# Squeak Noise From Rear Suspension

YEAR(S)	MODEL(S)	ADDITIONAL INFORMATION
2014 - 2019	Highlander, Highlander HV

**The information contained in this bulletin supersedes Service Bulletin No. T-SB-0016-16.**

Figure 1.

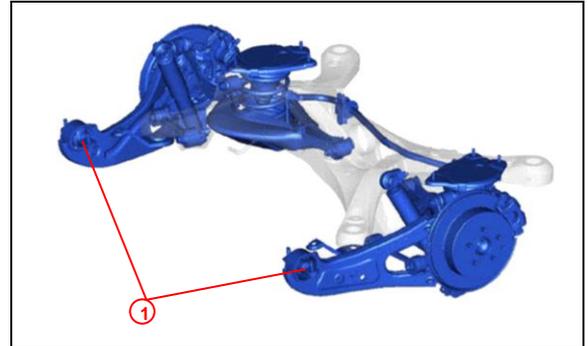
1. Confirm the condition exists.  
Using ChassisEAR™ (or equivalent), test-drive the vehicle over an uneven road surface, such as a sloped driveway, to verify the condition is coming from the bushings.

Applying soapy water to the suspected bushing may temporarily diminish the noise intensity and help identify the source of the noise.

Figure 2. Left-hand Side

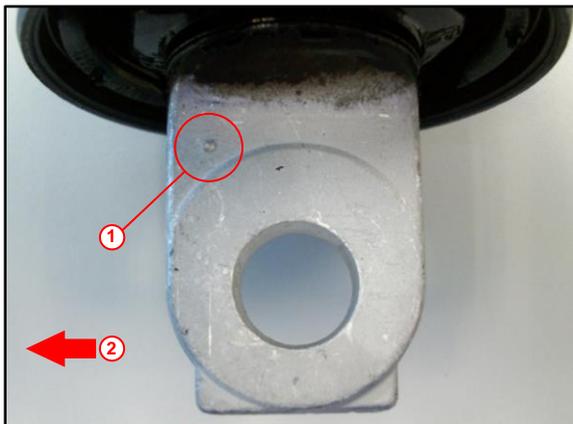
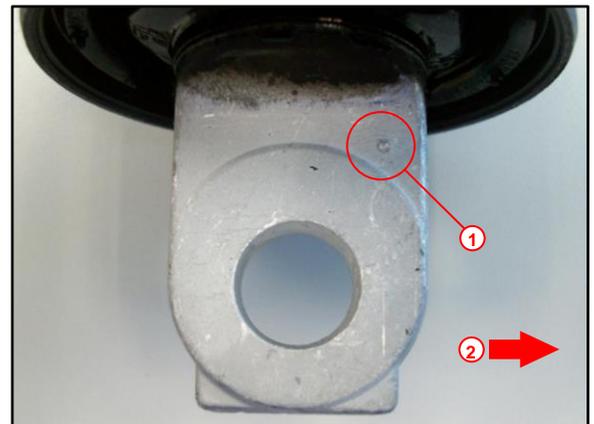
2. BEFORE installing NEW parts, confirm the identification mark as shown. If this mark is NOT present, the part is incorrect and SHOULD NOT BE INSTALLED.

The identification mark on the NEW part faces the outside of the vehicle.

3. Replace BOTH rear trailing arm assemblies even if ONLY one side is emitting the squeak noise.
